re: Landscaping Plan Review - Block 22
Wateridge Village Residential Development - Phase 1B - Block 22
1400 Hemlock Road - Ottawa

file: PG5345-MEMO.01 Revision 1

Landscaping Plan Review

Figure 1 – Engineered Pad Below USF For Tree Planting Purposes

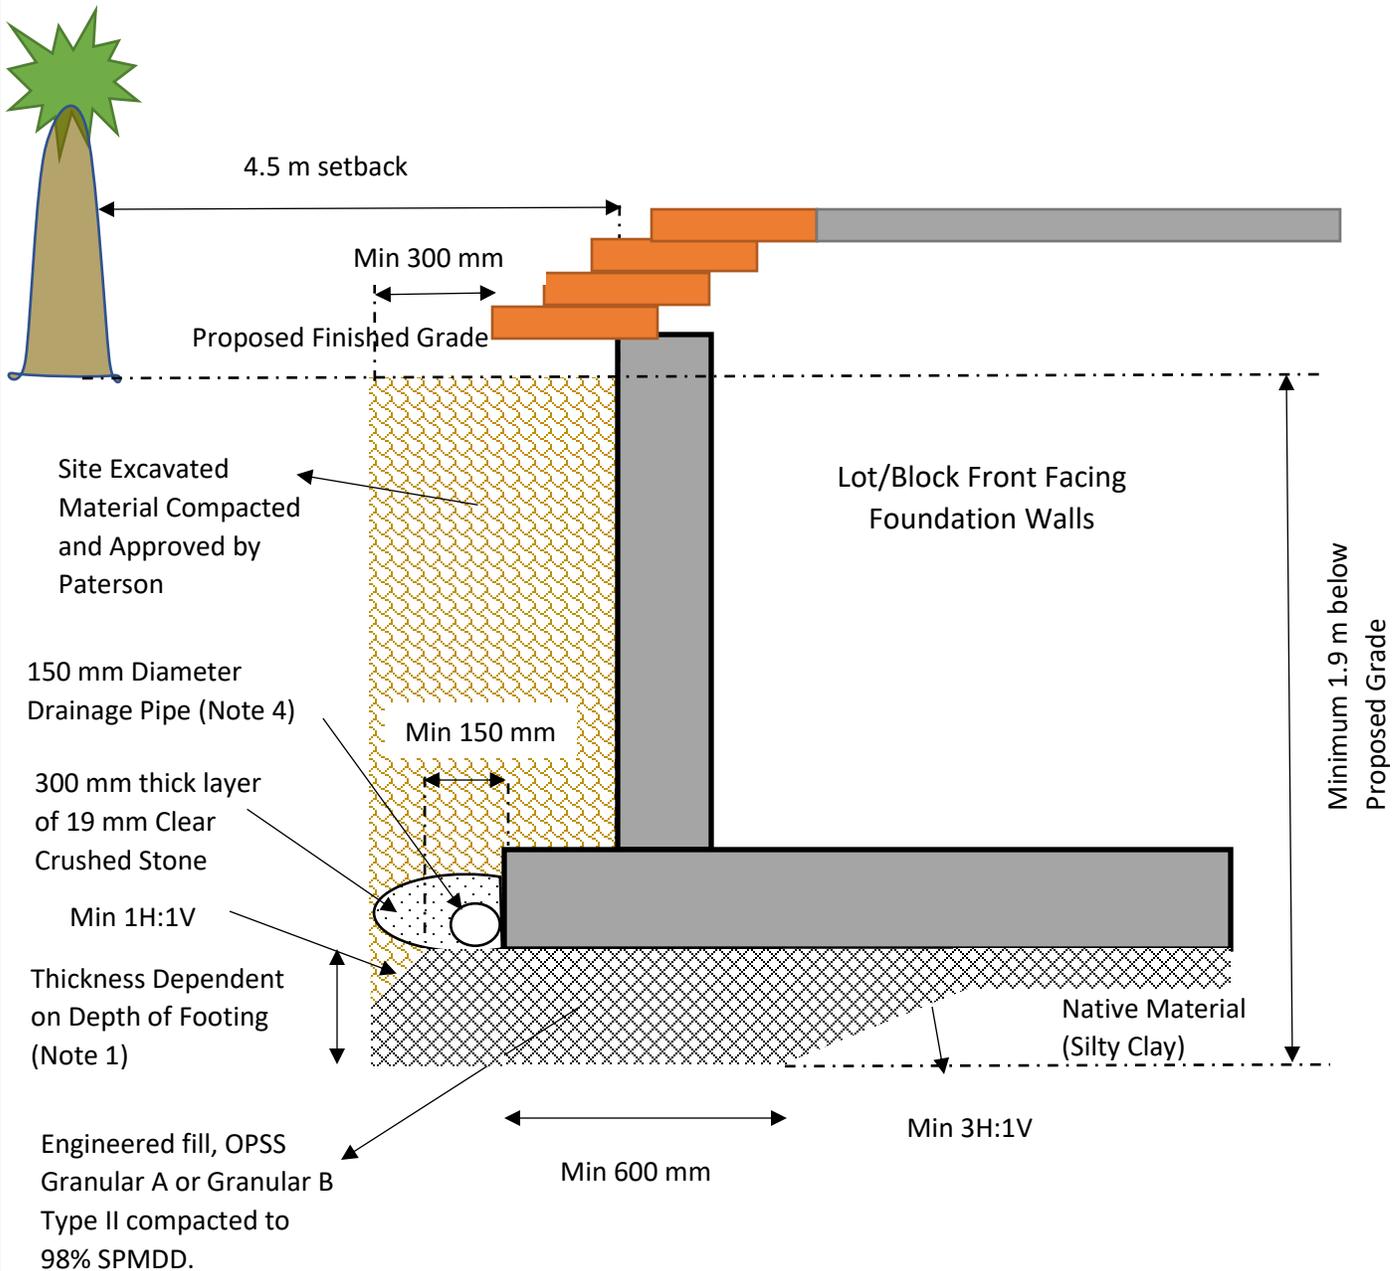
Based on our review of the proposed USF levels, it is our understanding that footing depths range between 0.28 to 2.3 m below proposed finished grade. To compensate for the reduced foundation depth, an engineered fill pad (OPSS Granular A or Granular B Type II) can be placed below the footing to a depth of 1.9 m below proposed finished grade surrounding the building. The engineered fill should be placed in 300 mm thick loose lifts and compacted to a minimum 98% of the material's SPMDD and approved by Paterson at the time of construction. The engineered fill pad will effectively increase the depth between the finished grade and the underlying silty clay deposit to the required 1.9 m which achieves the same goal as lowering the footing from a tree planting perspective. More recommendations will follow in Item D below. Reference can be made to Figure 1 attached for additional information.

In order to avoid lowering the footings and/or have differential settlement due to part of the riser being within the 4.5 m tree setback, it is recommended that where the front porch footings/risers are located within the 4.5 m setback, a granular backfill be introduced. Where the 1.9 m soil cover is not satisfied, the native material within the footprint of the front porch footings should be sub-excavated to a maximum 300 below the USF level and replaced with a granular pad consisting of OPSS Granular A or Granular B Type II placed in 300 mm loose lifts and compacted to 98% of the material's SPMDD. The granular pad should only be extended horizontally a minimum of 600 mm beyond the face of the foundation wall (towards the interior side of the front porch). It is important to note that a minimum 3H:1V frost taper will be required to transition from the granular pad to the native soil. Please refer to Figure 1 attached.

- Note 1: Where front porch footings have a minimum depth below finished grade of 1.9 m, the granular pad below the footings will not be required.
- Note 2: The thickness of the engineered pad is dependent of the depth of footings below proposed grade. The thickness of the engineered pad can be calculated by subtracting the depth of footing from 1.9 m.
- Note 3: The placement of the engineered fill should be reviewed and approved in the field by Paterson personnel.
- Note 4: The 150 mm diameter perforated, corrugated drainage pipe should be geotextile wrapped, placed at the founding level and connected to a positive outlet with a gravity connection.
